HAERSES ROAD QUARRY EXTRACTION AREA MODIFICATION

Response to Submissions

June 2017

Project Director: John Merrell
Project Manager: Lachlan Sweeney
Report No. 3479/R06/Final
Date: June 2017

FIGURE 1.2
Proposed Modification

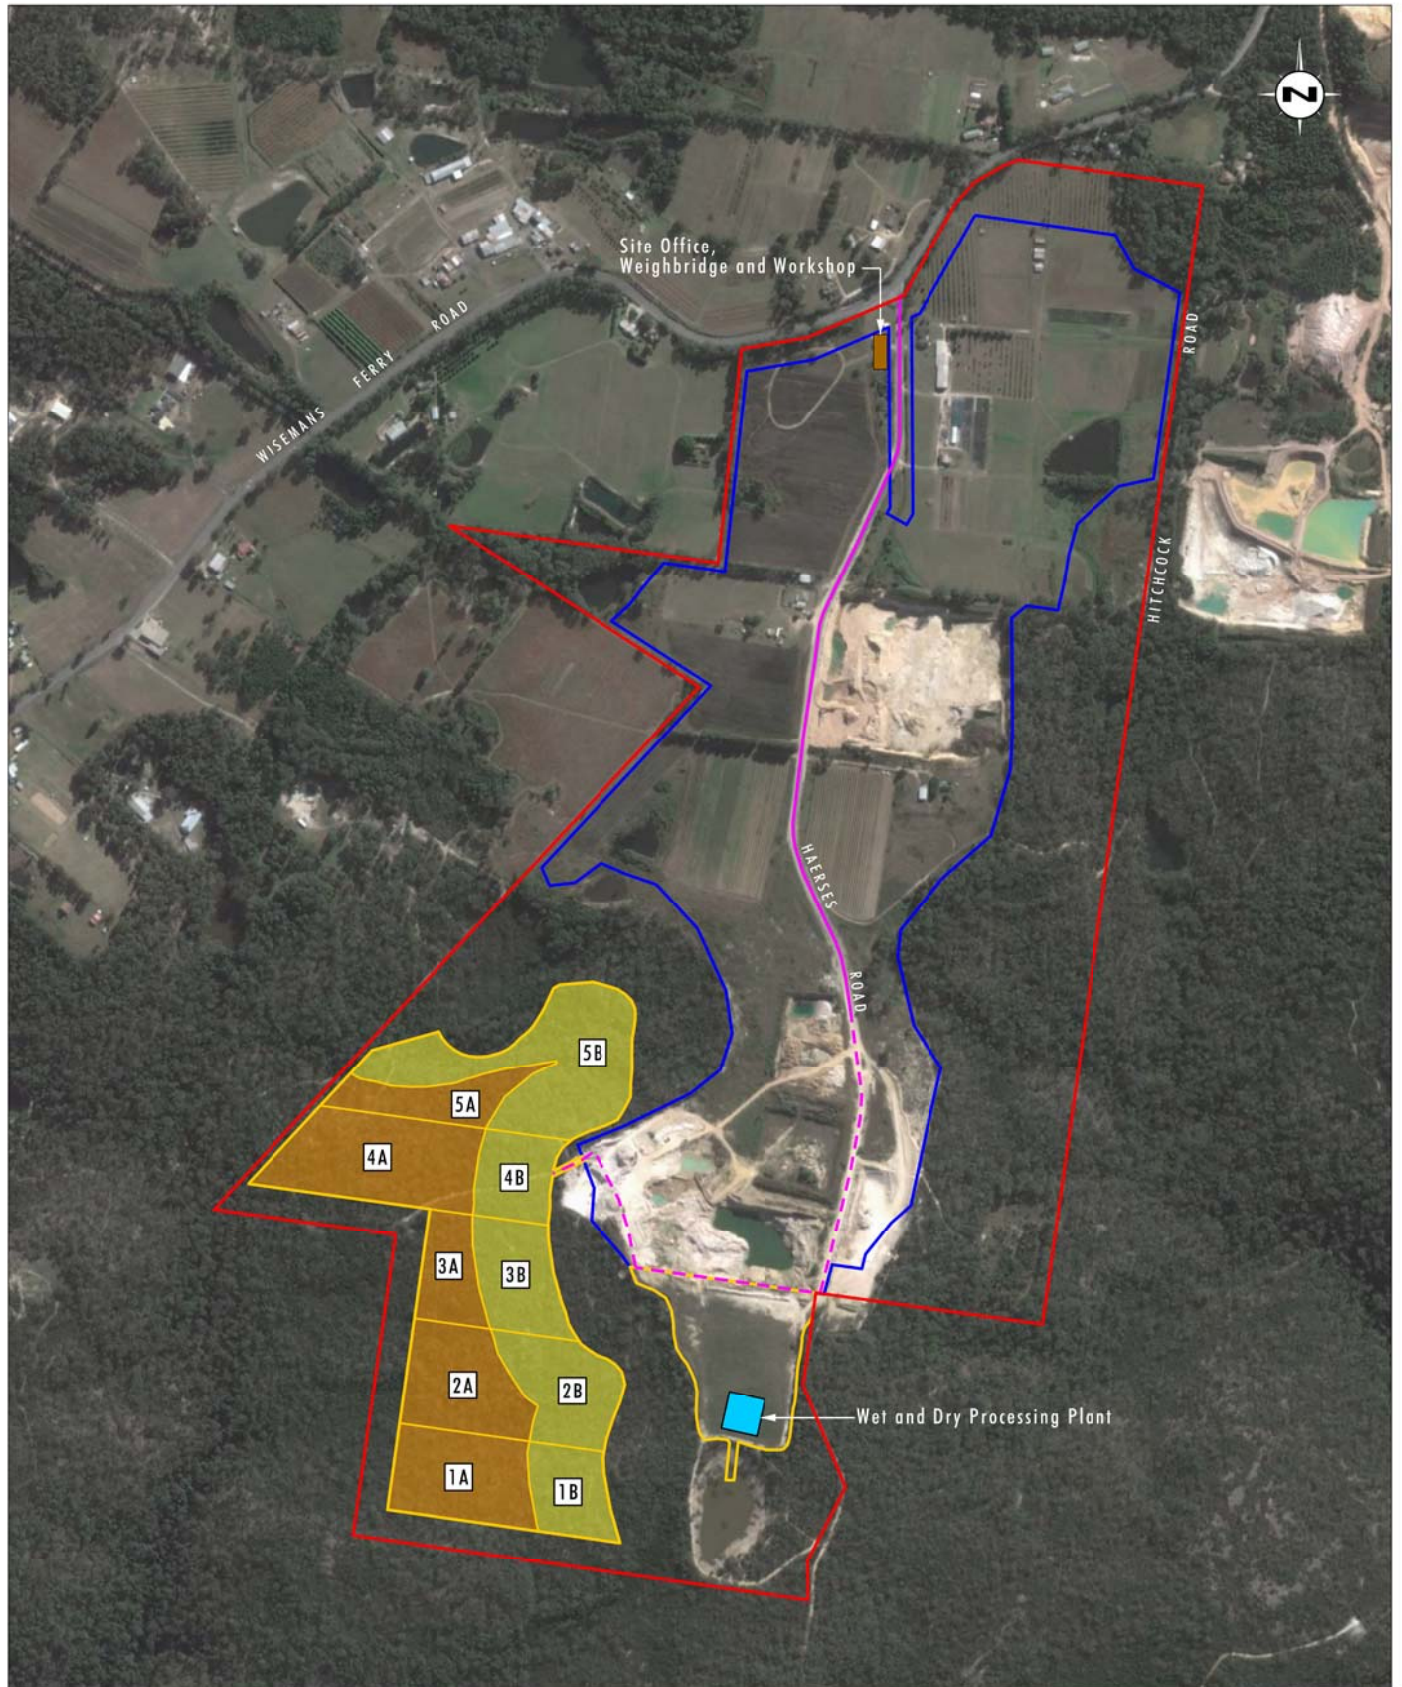
Following discussions with government agencies in relation to groundwater monitoring to confirm impact assessment predictions, Dixon Sands has agreed to change the extraction sequence from that identified in the EA. With reference to **Figure 1.2**, the original extraction sequence was to commence in Cell 1A and then subject to groundwater monitoring in the 'B' series of cells confirming the predictions of the Groundwater Impact Assessment, move into Cell 1B and then progress north moving from 2A to 2B and so on.

To allow for additional time to monitor for any changes to groundwater conditions, the currently proposed extraction sequence (refer **Figure 1.2**) is as follows:

It is noted that this sequence may change over the life of the quarry in response to the results of ongoing groundwater monitoring. Any changes to the sequence will be identified through the Annual Review for the quarry.

FIGURE 2.1

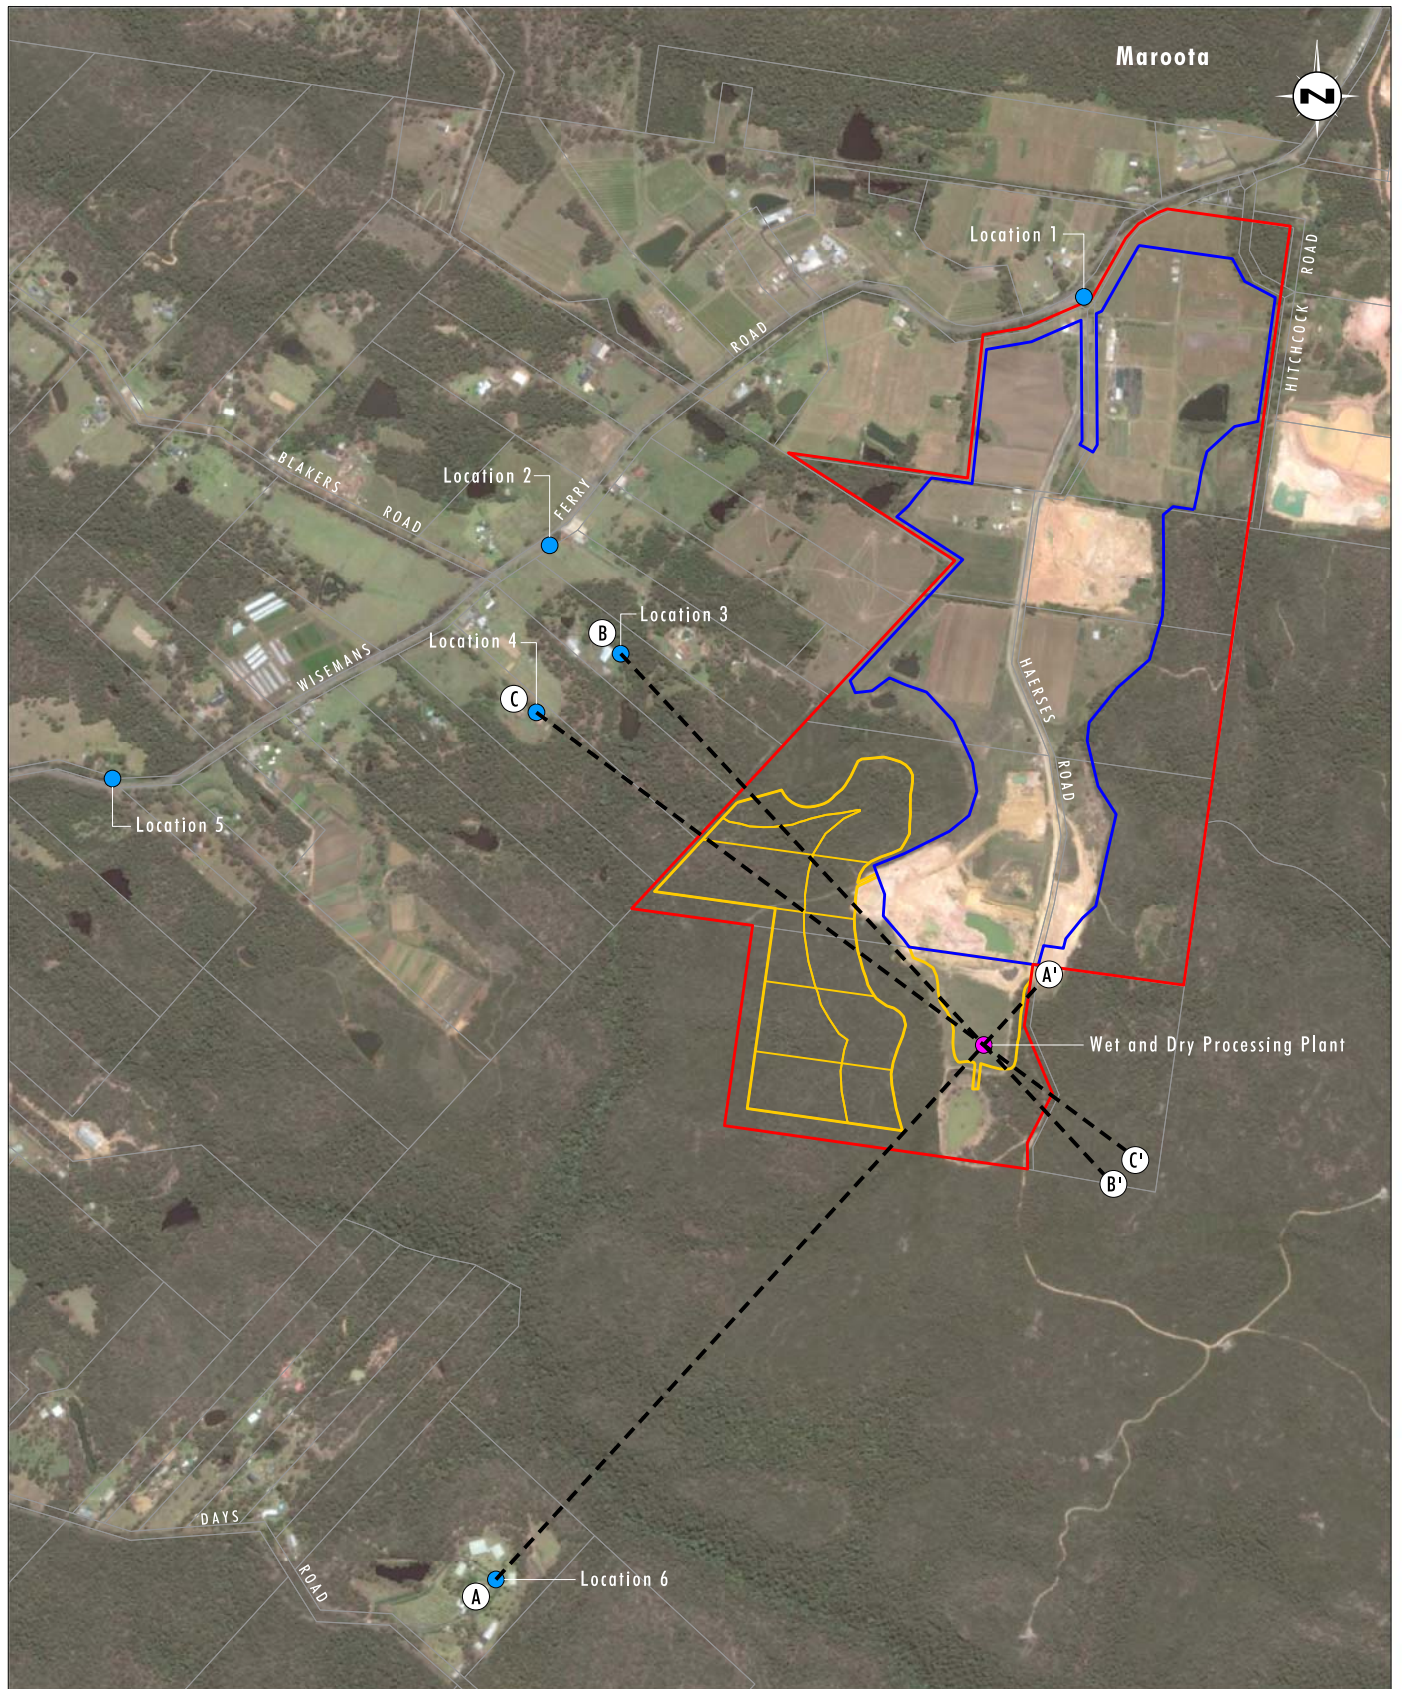
Further visual assessment including three dimensional terrain modelling has been undertaken for the Modification. The purpose of the further assessment was to determine if there were any surrounding residences or public viewing locations from which the additional extraction area, earth bunds and/or acoustic fencing and processing plant would be visible from the surrounding landscape and residences.

The detailed terrain model of the area surrounding the Modification was examined to determine potential viewing locations at which to run a detailed radial analysis. The radial analysis identifies the parts of the terrain that are visible (and the Modification if visible) from the selected viewing location. Three publicly accessible locations on Wisemans Ferry Road were selected where motorists potentially have a view to the proposed extraction area (refer **Figure 2.1**).

Three dwelling locations were also selected to the west and south of the proposed extraction area based on their proximity (closest residences with potential views) and position (elevated position) within the landscape (refer **Figure 2.1**).

Transects from the three dwelling locations towards the highest point within the Modification area, and the wet and dry processing plant location, were created to determine whether there are line of sight views from these locations. The locations of the transects are shown on **Figure 2.1**.

Figure 2: Plan of proposed monitoring sites

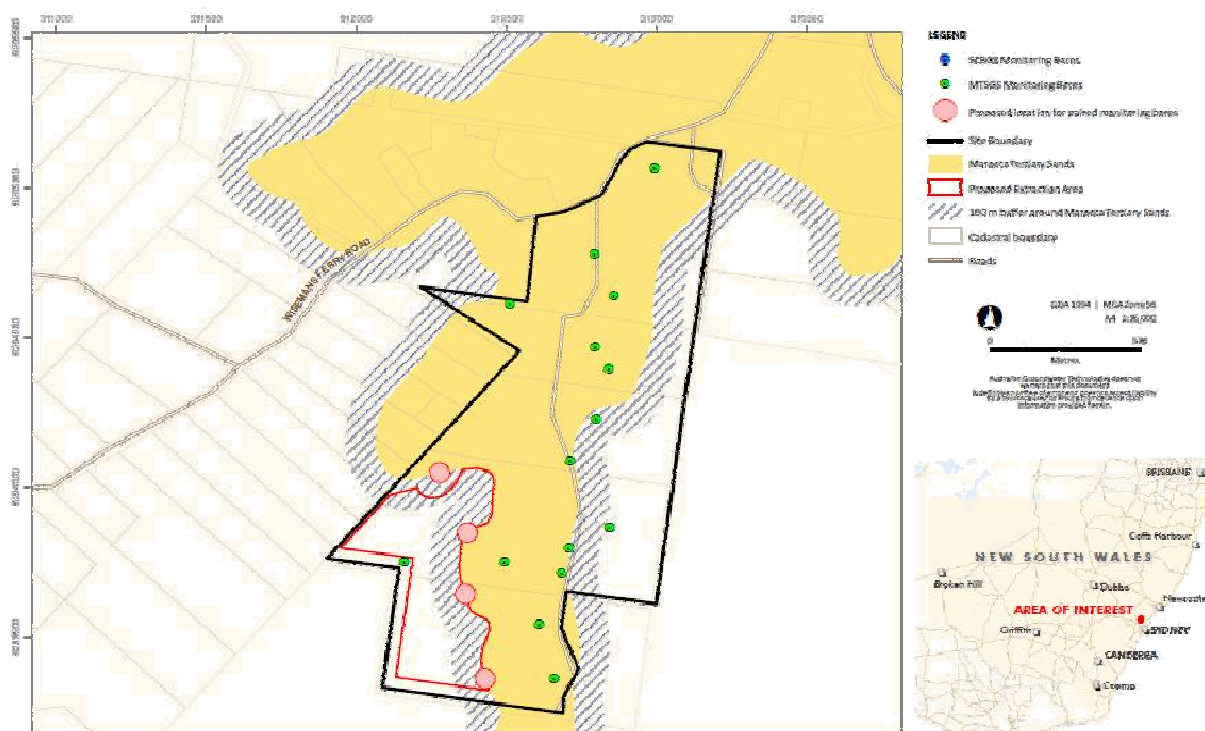
<ul style="list-style-type: none"> Locating additional clustered monitoring bores between the proposed development and: Maroota Sands Coastal Upland Swamps Users to the north, west and south 	<p>Proposed locations are presented on Figure 2. These are nominal as actual locations will be dictated by site access. Groundwater users exist to the west but these bores target the deep regional groundwater system of the SBCGS (See Figure 6 of the AGT groundwater assessment). These users will not be impacted as the proposed extraction will be at least 2 m above the wet weather groundwater level as determined by BH5 which is located between these existing users and the eastern boundary of the proposed extraction area. The focus of groundwater monitoring within the nominated buffer zone between the extraction area and MTSGS and Coastal Upland Swamp (Figure 2) addresses the requirement to monitor the Maroota Sands and Coastal Upland Swamps. The additional bores will also assist in confirming the wet weather groundwater levels for determination of base of extraction to be 2m above wet weather level.</p>	<p>DPI Water considers that the wet weather groundwater level has not been established for the site as yet and requests further detailed drilling of clustered bores to gain an understanding of hydrological conditions on site.</p>

Figure 1: Proposed drilling locations

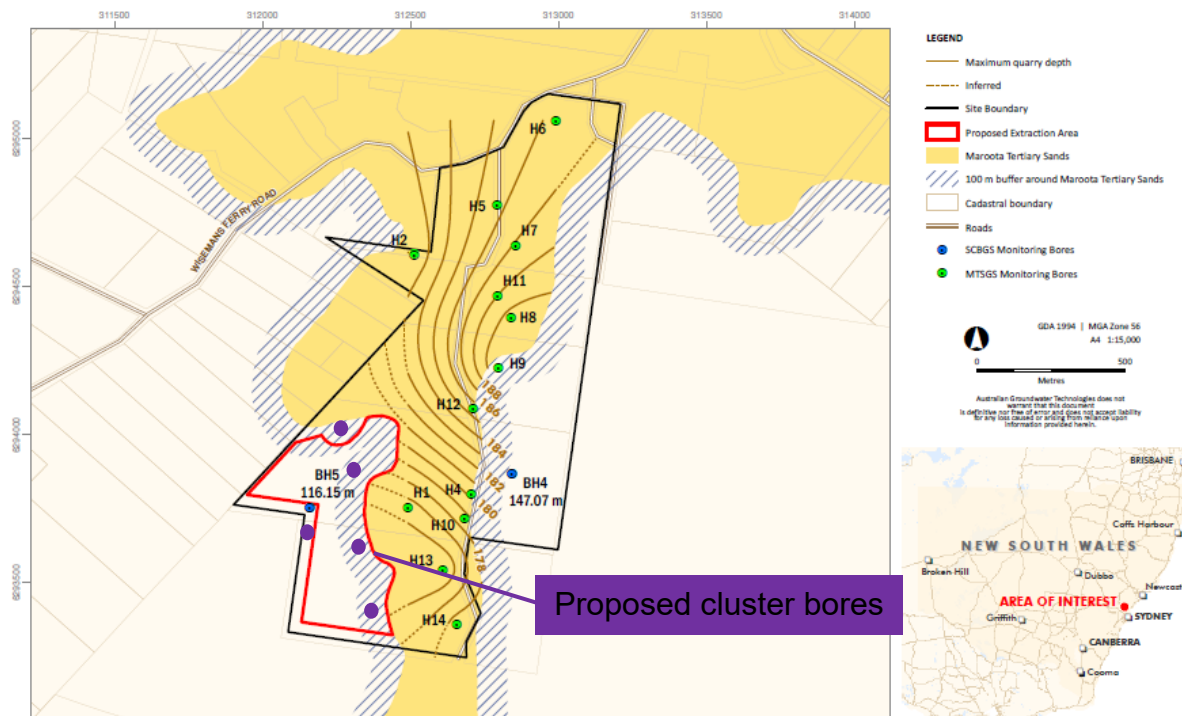
A 100m buffer zone, comprising low permeability Hawkesbury Sandstone will be put in place along the western boundary of the Maroota Tertiary Sands Groundwater Source (MTSGS) (Figure 1). The existing groundwater monitoring network will be enhanced by the drilling of clusters of monitoring bores positioned within the proposed buffer zone (see **Figure 1** below).

A fifth additional monitoring bore will be drilled to the west of the extraction area and just south of existing bore BH5, as shown in **Figure 1** above, to satisfy monitoring requirements between other water extractors to the west and south/west of the site.

Figure 13: 24-hour PM10 concentration - R6 increment matched with Maroota School (µg/m³)

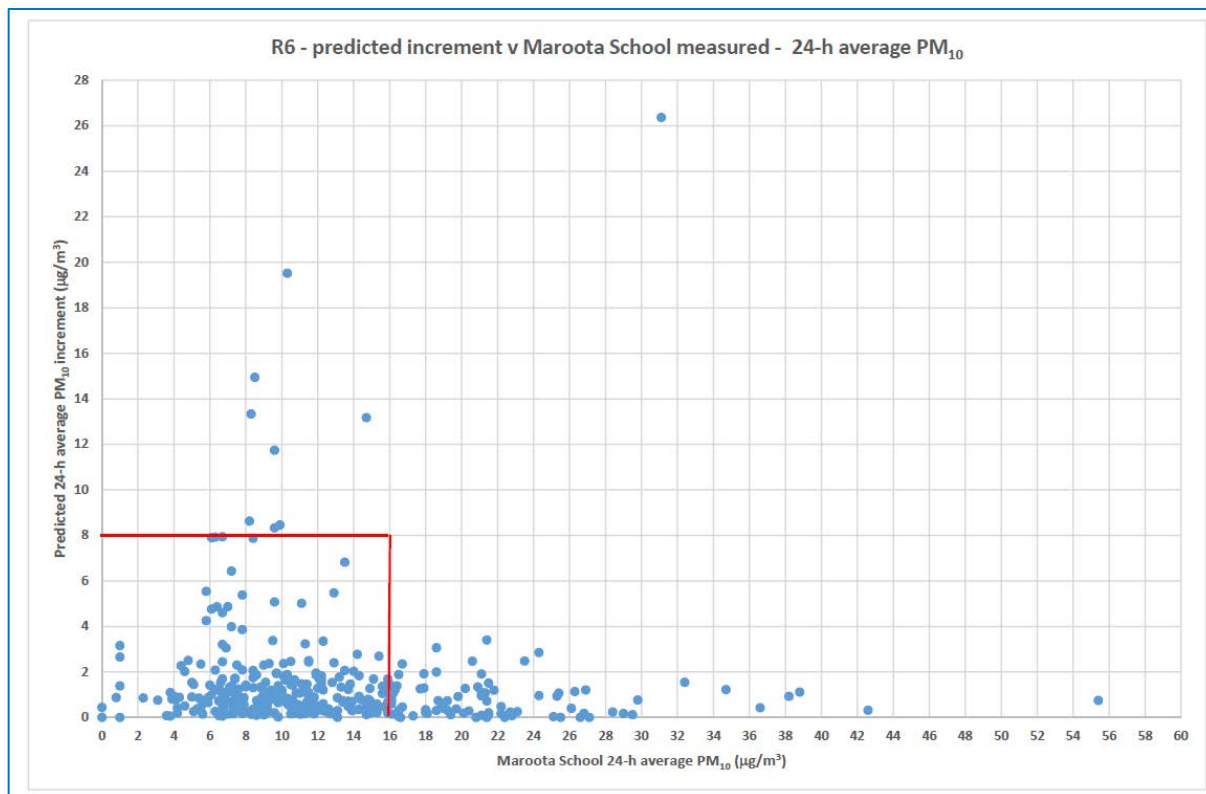
As discussed above, PEL has advised that a review of their cumulative assessment for the Modification identified that the wrong data had been applied for the existing air quality. When the correct background data are combined with the increment due to the Modification, there is only one additional exceedance predicted of the 24-hour average PM₁₀ criterion of 50 µg/m³ predicted at one receptor - R6, and no predicted exceedances of the 24-hour PM_{2.5} criterion of 25 µg/m³. PEL further notes that a number of emission controls that will be in place at the Modification (per Table 5 **Appendix 4**) that were not explicitly applied to the emission estimation used in the dispersion modelling and as such it is considered there is very limited potential for the Modification to result in any additional exceedances of the air quality criteria.

When considering the management measures, Figure 13 of **Appendix 4** shows a scatter-plot of the predicted 24-hour average PM₁₀ concentrations at R6, matched with the corresponding 24-hour average PM₁₀ concentration measured at Maroota School on the same day. The figure shows that when the predicted increment at R6 exceed 8 µg/m³, the measured concentrations at Maroota School are 16 µg/m³ or below. It is therefore considered the current management measure of 42 µg/m³ remains adequate.

When considering the management measures, Figure 13 shows a scatter-plot of the predicted 24-hour average PM₁₀ concentrations at R6, matched with the corresponding 24-hour average PM₁₀ concentration measured at Maroota School on the same day. The figure shows that when the predicted increment at R6 exceed 8 µg/m³, the measured concentrations at Maroota School are 16 µg/m³ or below. It is therefore considered the current management measure of 42 µg/m³ remains adequate.
